# Access Compliance Report

## Public Rights-of-Way

### (Curb Ramps)

Intersection ID: 29420	Main Street: BRADSTREET COMMONS WY	Cross Street: SALINGER WY	Location: W
ADA ID: 83130D038379	Ramp Type: Perp	Initial Pass/Fail: Fail	Overall Compliance: No
Severity Score: 10			
Codes/Mitigation Info/Possible Solution		Field Measurements/Component Compliance

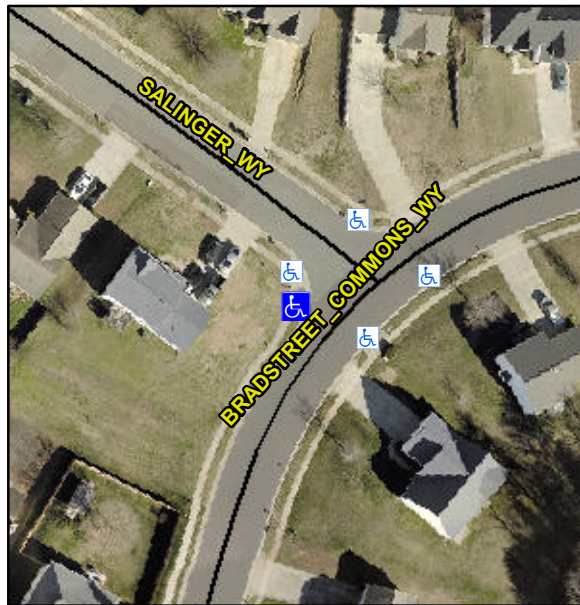
**Not Found, R304.5.1**

Compliance	Description	Data	Compliance	Description	Data
N/A	Ramp Length (in)	48.5	Yes	Ramp Slope (%)	5.6
No	Ramp Width (in)	45.5	Yes	Ramp XSlope (%)	4.0
N/A	Flare Type LT	N/A	N/A	Flare Type RT	N/A
N/A	Flare Slope LT (%)	N/A	N/A	Flare Slope RT (%)	N/A
N/A	Flare Traversable LT?	N/A	N/A	Flare Traversable RT?	N/A
N/A	Landing Length (in)	N/A	N/A	DWS Provided?	N/A
N/A	Landing Width (in)	N/A	N/A	DWS Contrast?	N/A
N/A	Landing Slope (%)	N/A	N/A	DWS Length (in)	N/A
N/A	Landing X Slope (%)	N/A	N/A	DWS Full Width?	N/A
N/A	Landing Curb? (Y/N)	N/A	N/A	DWS Offset (in)	N/A
N/A	Shared Landing?	N/A			
N/A	Gutter Ponding?	N/A	N/A	Gutter Slope (%)	N/A
N/A	Gutter Lip Ht (in)	N/A	N/A	Gutter X Slope (%)	N/A
N/A	Painted X Walk1?	No	N/A	Painted X Walk2?	N/A
	X Walk 1 Direction	To SE		X Walk 2 Direction	N/A
N/A	X Walk 1 Width (in)	N/A	N/A	X Walk 2 Width (in)	N/A
	X Walk 1 Slope (%)	6.4		X Walk 2 Slope (%)	N/A
	X Walk 1 X Slope (%)	4.6		X Walk 2 X Slope (%)	N/A

**Remove & Replace Entire Ramp.**
